Docket Items #4 & #5
BAR CASE # 2017-0285 &
2017-0286

BAR Meeting
September 20, 2017

ISSUE: Permit to Demolish/Capsulate, Certificate of Appropriateness for Additions and Alterations, and Waiver of Rooftop Mechanical Screening Requirement

LOCATION: 433 South Lee Street

Figure 1: Proposed additions (red = one-story addition, blue = second story addition)

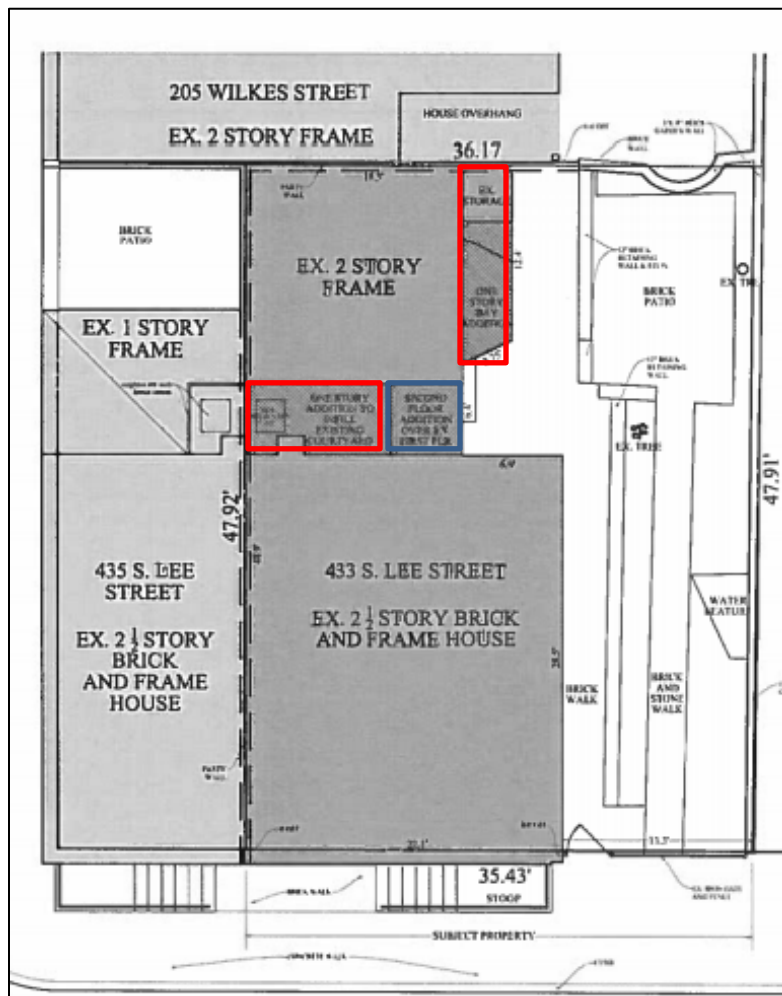
Three separate minor additions are proposed as part of the renovation of this historic property: an existing interior courtyard will be enclosed for a one-story addition; a second floor addition will be constructed over the existing one-story hyphen; and, a one-story bay window addition will be constructed on the north elevation of the existing two-story frame addition (Figure 1).

The amount of new square footage being added to the property is relatively small and does not impact the front or north elevation of the masonry main block. An existing interior courtyard between the main block and the two story rear addition will be enclosed to become part of the first floor (68 square feet), and a second story will be added to the existing one-story hyphen connecting the main block and the rear addition (28 square feet). On the existing frame addition the triple French door will be removed and a projecting bay window will be added, as well as a new casement window on the second floor. The existing shed at the rear of the property will be reduced in size and the area adjacent to the building will continue to be used for storage. Because the bay window and reconfigured shed are located in a required rear yard, the applicant obtained approval of a special exception from the Board of Zoning Appeals on September 14, 2017 (BZA 2017-0024) in order to construct the bay window and retain the smaller shed.
